Project Name: Sexton Auditorium

Project No.: 221125-180

Date: 12/11/2025

This Addendum is issued to inform the bidders of modifications in the scope of work being bid for this project.

6 SOFFIT AT FIRST FLOOR FOYER
3/4" = 1'-0" A3.3

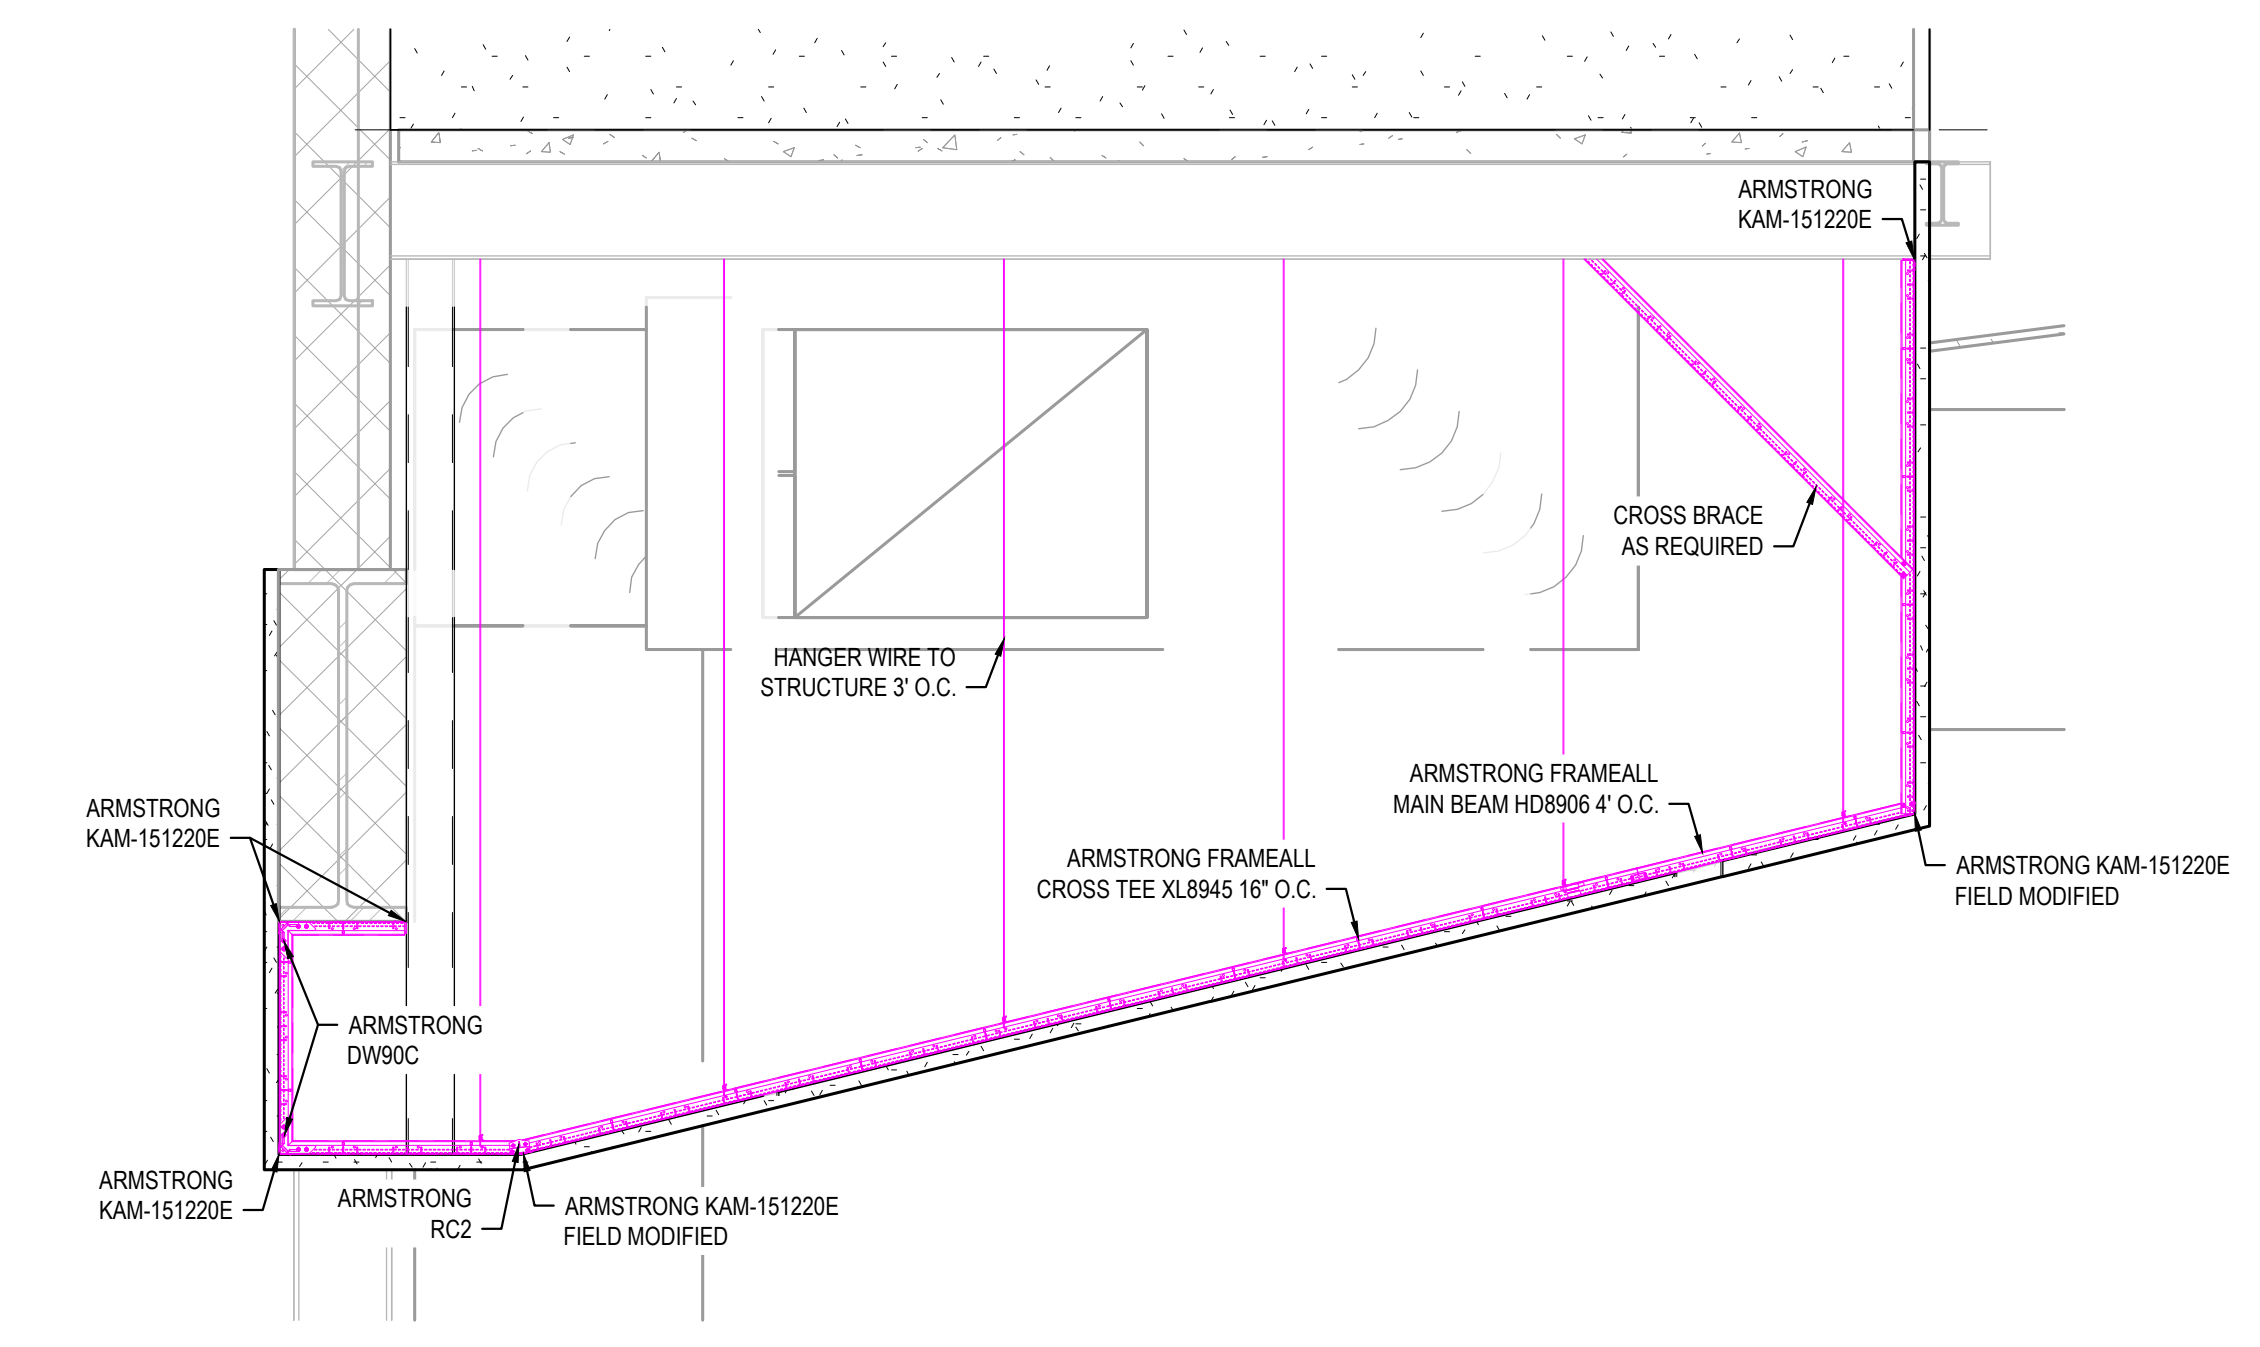
1. Provide Armstrong FrameALL framing system in lieu of conventional stud framing. See supplemental drawing No. 1 for additional information.

FIRST FLOOR MECHANICAL HVAC
PLAN

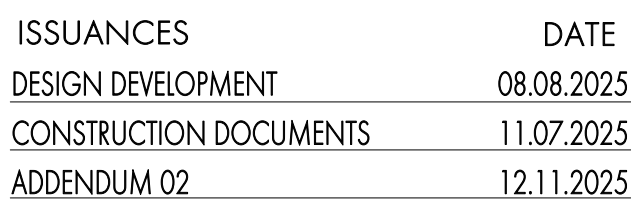
H2	PROVIDE AND INSTALL NEW RA GRILLE AT SAME LOCATION AS EXISTING. FINE VERIFY SIZE, QUANTITY AND LOCATION PRIOR TO INSTALLATION.
H3	REMOVE EXISTING RA GRILLE. INSTALL NEW RA GRILLE SYSTEMS MOUNTED TIGHT TO EXISTING CEILING AT ~33 FT ABOVE 1ST LEVEL FINISHED FLOOR. COORDINATE LOCATION WITH LIGHTS AND AIRFLOW EQUIPMENT IN CEILING. REFER TO REFLECTED CEILING LAYOUT FOR EXISTING AND PROPOSED LIGHTS. COORDINATE WITH ELECTRICAL FOR LIGHTS NOT LIMITED TO THROWS, VELOCITIES, MATERIALS, SPACING, ETC. COORDINATE FABRIC WITH MECHANICAL FOR AIRFLOW EQUIPMENT.
H4	REMOVE SA DUCT FROM EXISTING CEILING THROUGH SPOFF WALL AND INSTALL EXPOSED TO AIRFLOW. INSTALL DUCT AS HIGH AS POSSIBLE AND ROUTE AS SHOWN ALONG WITH LIGHTS. COORDINATE WITH MECHANICAL FOR AIRFLOW EQUIPMENT. LIGHTS AND LIGHTS AS REQUIRED. RECTANGULAR DUCT SHALL BE DOUBLE WALL METAL DUCT.
H5	SA DUCT DOWN THROUGH FLOOR TO SPACE BELOW. COORDINATE ROUTING WITH MECHANICAL FOR STRUCTURES. REFER TO STRUCTURAL DETAILS FOR DUCT OPENING FRAMING DETAILS.
